# MEMORANDUM

| <b>Service</b>              | WBC Ecology                                                                                                                                                                                                                                                                                                              | <b>App No:</b> | 242364 |
| <b>Address:</b>             | 105 Colemans Moor Road, Woodley, Wokingham, RG5 4DA.                                                                                                                                                                                                                                                                     |                |        |
| <b>Proposal:</b>            | Application for submission of details to comply with the following conditions of planning consent 240833 dated 19/08/2024. Condition 4 relates to a Construction Environmental Management Plan (CEMP); 5 to hard and soft landscaping; 6 to drainage details; 7 to biodiversity enhancements and 8 to a lighting scheme. |                |        |

### **Ecological Enhancements**

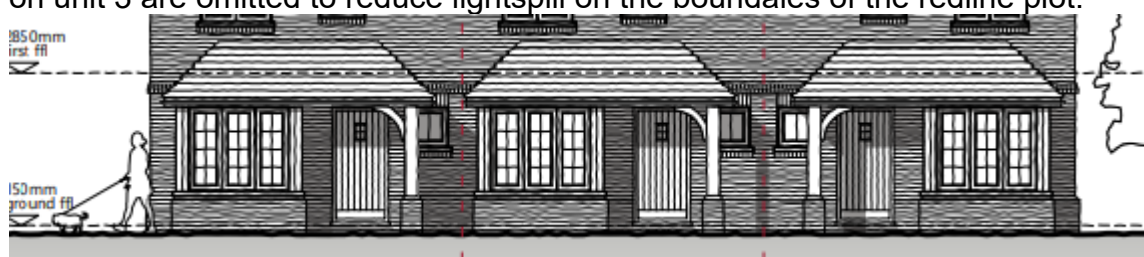
I request that the bee box is relocted so that it is close to vegetation, but where plants wont obscure or shade the entrance. The PEAR recommended that bat tubes and bat boxes be integrated with the 3 units. It is not clear from the Ecological Enhancements document how many bat access tiles and how many integrated

tubes the applicant proposes to provide, which should therefore be confirmed prior to discharge of condition 7.
